BWROG-09020
March 20, 2009

SUBJECT: BWROG Response to NRC Requests for Additional Information (RAIs) on GEH BWROG Topical Reports NEDC-33347P Revision 0 (Proprietary Version) and NEDO-33347 Revision 0 (Non-Proprietary Version), "Containment Overpressure Credit for Net Positive Suction Head (NPSH)"

Final BWROG Responses To NRC Requests For Additional Information
Regarding Containment Overpressure Credit For NPSH (NEDO-33347)

Figure 1: Flow diagram for statistical containment analysis for LOCA, ATWS, SBO, and Appendix R events

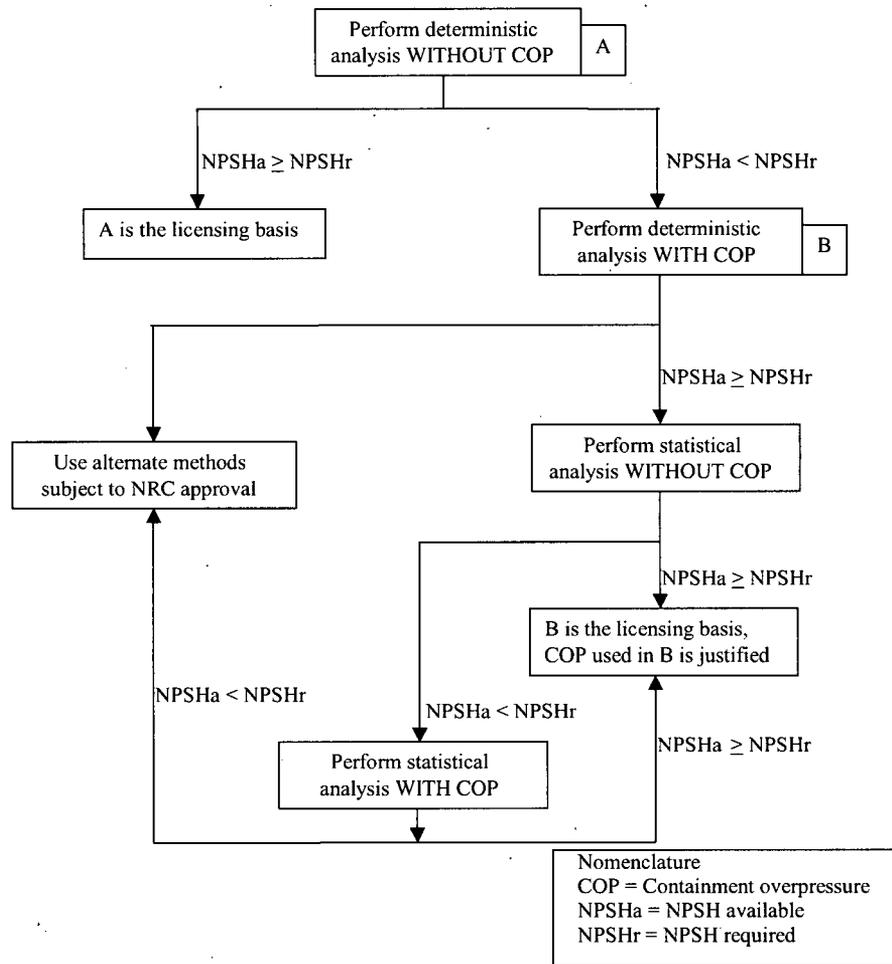
20. Section 4.3: The TR states that the proposed method for evaluation of special events will utilize nominal input values. It goes on to state that if this approach does not show that $NPSHa - NPSHr \geq 0$ then the statistical approach using mean values will be used.
- How is the mean determined?
 - If the statistical approach does not show acceptable results, what is the next step?

NRC Supplemental Comment: a. & b The LTR proposal that the deterministic analysis be the licensing basis when it yields an unacceptable result is not acceptable. The staff proposal of an acceptable process is shown in Figure 1 which applies to containment analysis for LOCA, ATWS, SBO and Appendix R events. If "statistical analysis with COP" (C in Figure 1) is used as a licensing basis, a revised analysis would not be necessary if the change in data were small.

An NRC-developed flow chart is below:

- a. The mean output statistical approach uses the Monte Carlo method to produce 59 containment analyses. The results of these analyses are utilized to produce a term called Hww. Each of the 59 containment analyses produces Hww for each time step. For each time step of the 59 analyses, the maximum Hww, mean Hww and the minimum Hww can be determined and plotted. Special event determined mean values would have a family of curves similar to the examples in Figures A-1 and A-2 of the topical report. The mean Hww term per each time step is combined with the elevation head and the head losses from the suction strainer and suction line per time step to produce a mean statistic NPSHa value.

- b. The next step if the statistical approach does not show acceptable results would be to review appendix C and D of the topical report titled "Alternate methods to containment overpressure" and "COP Credit" and implement scenario changes or plant modifications as appropriate.

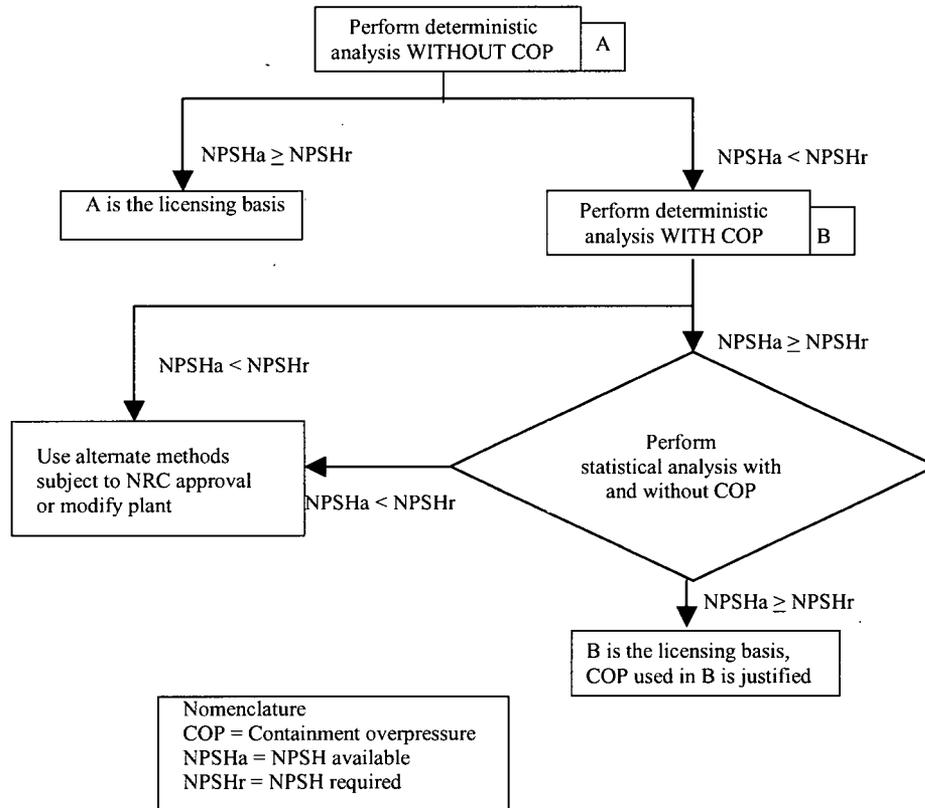
The NRC clarified the definition of "unacceptable result" to mean "NPSHa < NPSHr," and

an acceptable result to mean “NPSHa > NPSHr.” The BWROG understands that the NRC objects to retaining the deterministic licensing basis if the deterministic results are unacceptable and the corresponding statistical results are acceptable. The BWROG believes that the corresponding deterministic and statistical analyses will either both be acceptable or both unacceptable, so the situation postulated by the NRC should not arise. If it does, the licensee will need to take alternate action. The BWROG recommends the following changes to the NRC flow chart to improve clarity:
